MINERALS PROGRAM INSPECTION REPORT
PHONE: (303) 866-3567

MINE NAME: Cresson Project	MINE/PROSPECTING ID#: M-1980-244	MINERAL: Gold	COUNTY: Teller
INSPECTION TYPE: Monitoring	INSPECTOR(S): Patrick Lennberg and Brock Bowles	INSP. DATE: November 4, 2019	INSP. TIME: 09:30
OPERATOR: Cripple Creek & Victor Gold Mining Company	OPERATOR REPRESENTATIVE: Katie Blake	TYPE OF OPERATION: 112d-3 - Designated Mining Operation	
REASON FOR INSPECTION: Normal I&E Program	BOND CALCULATION TYPE: None	BOND AMOUNT: \$209,491,188.00	
DATE OF COMPLAINT: NA	POST INSP. CONTACTS: None	JOINT INSP. AGENCY: None	
WEATHER: Clear	INSPECTOR'S SIGNATURE: 	SIGNATURE DATE: November 8, 2019

Photo 10: AGVLF 10,200' level, ponding water indicated by yellow arrows and spraying water indicated by blue arrow

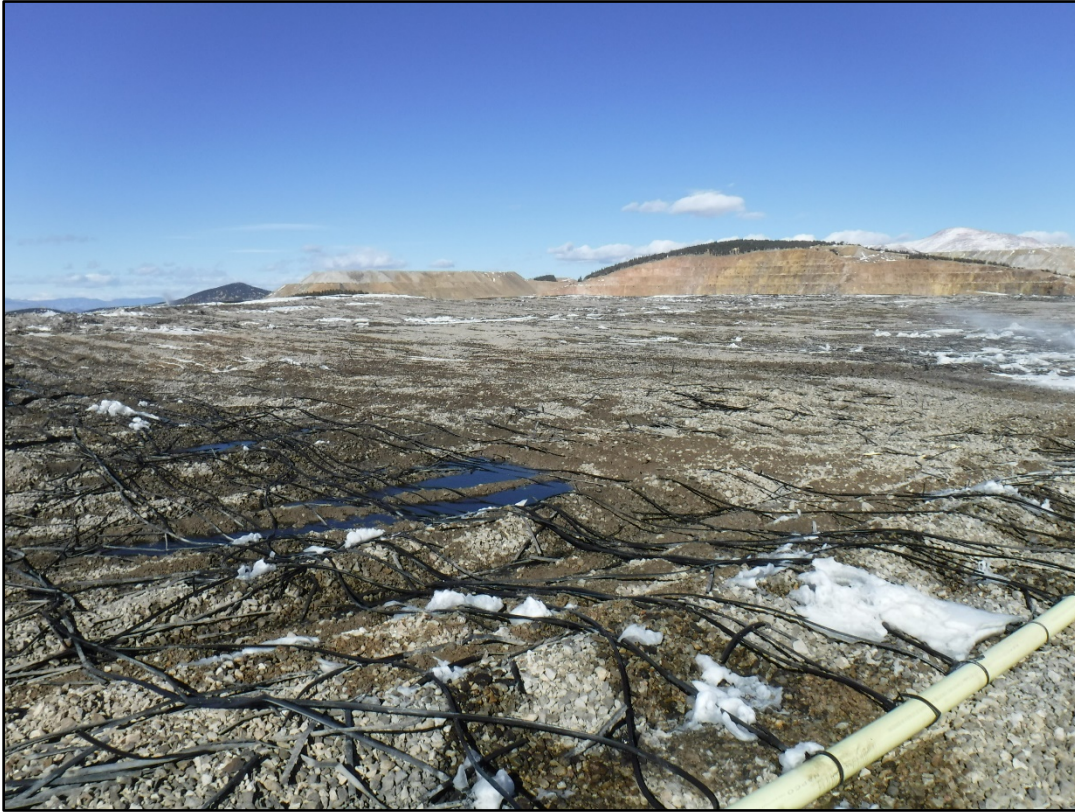
The current and maximum elevation of ore placement in the AGVLF is 10,400 feet (for Phase V). The Division inspected active leaching surfaces on the AGVLF. These surfaces were well saturated and ponding of leachate, greater than 3 feet by 3 feet, was observed. In addition, ponding of leachate was observed on the lower 10,200 foot level, although not as common as was observed on the upper level. The snow storm last week, the reason for rescheduling this inspection, resulted in several inches of snow accumulation. The weekend after the storm and prior to the inspection the temperatures rose substantially resulting melting of most all of the snow that fell. It is believed that the majority of the ponded water is a result of the quick snow melt. Prior to writing this inspection report the Operator stated that they were in the process of ripping the surface material to promote infiltration. The inspectors did note that a crew had arrived at the 10,400 foot level to begin addressing the ponding issues.
